APPLICATION FOR HISTORIC AREA WORK PERMIT

LOCAL ADVISORY COMMITTEE REVIEW FORM

c. Address of Property: 7206 Holly Ave

Homes in Takoma Park, from the 1888 B.F. Gilbert real estate brochure.

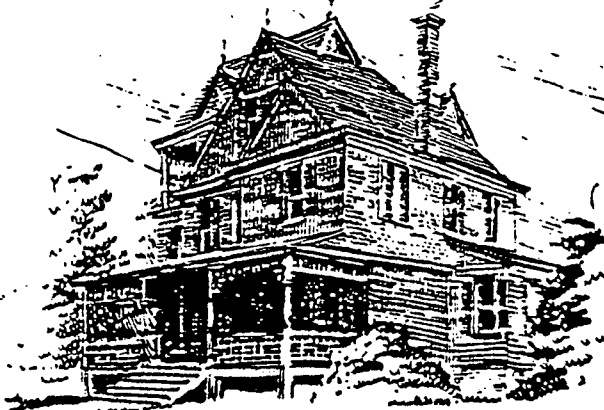
* notice original open front porch on 2nd floor with balusters to match lower porch

NEW REAR ELEVATION

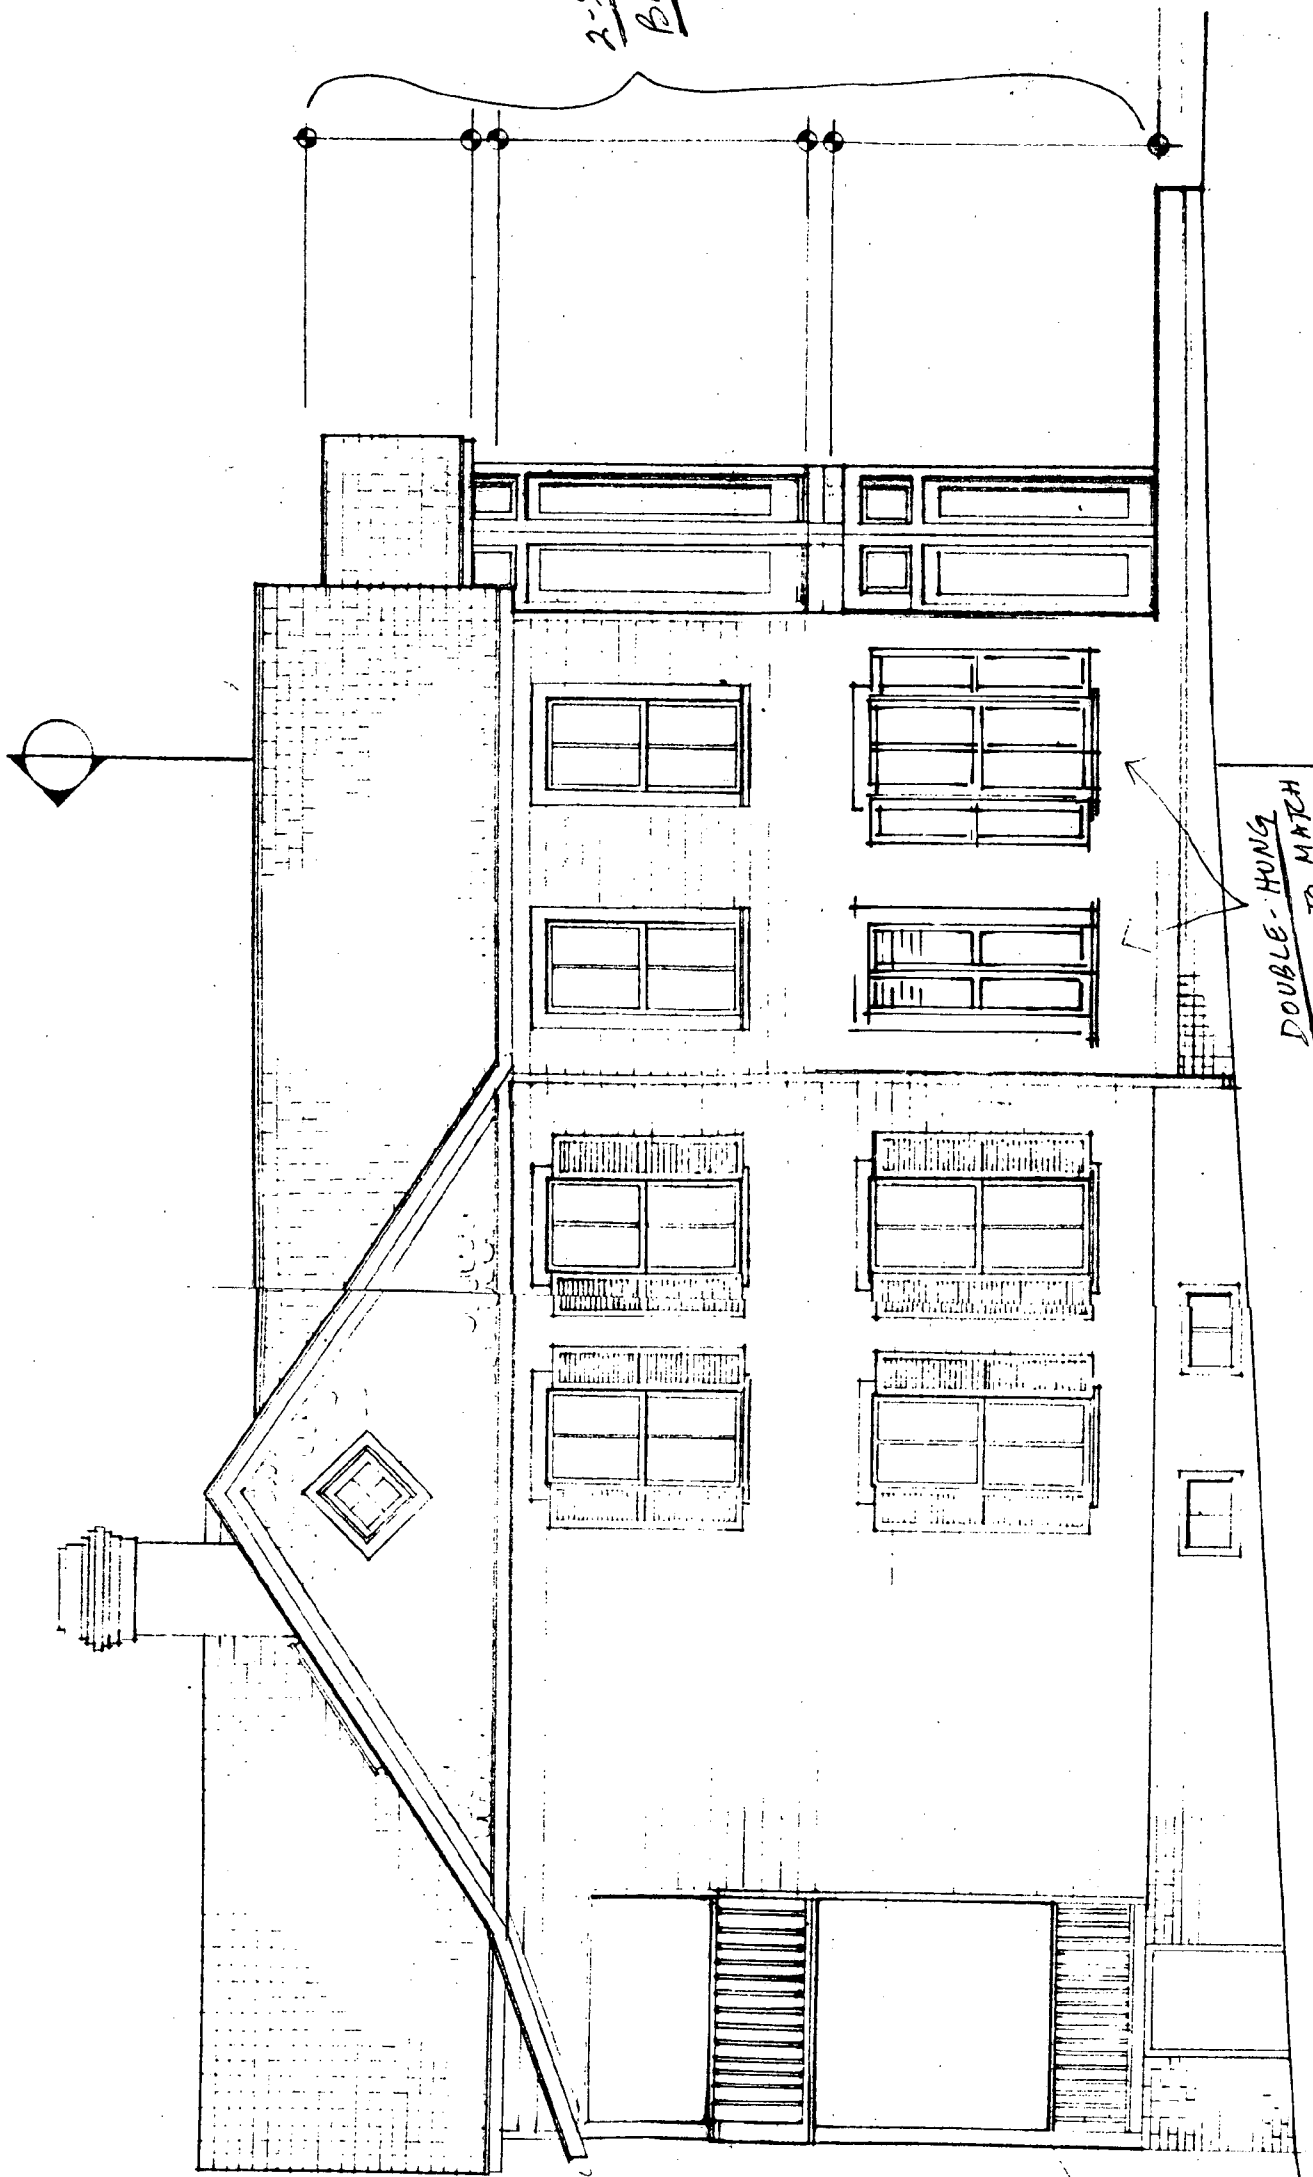
REAR ELEVATION - EXISTING

LOW-PROFILE SKYLIGHT

2-STOUREY BAY

GREENHOUSE WINDOW BUMP-OUT

2-STORY
BAY

NEW NO. SIDE ELEVATION

DOUBLE-HUNG
WINDOWS TO MATCH
2ND FLOOR
WINDOWS

AD TO ORIGINAL
D W BALUSTERS
- SEE ILLUS.
THE ESTATE
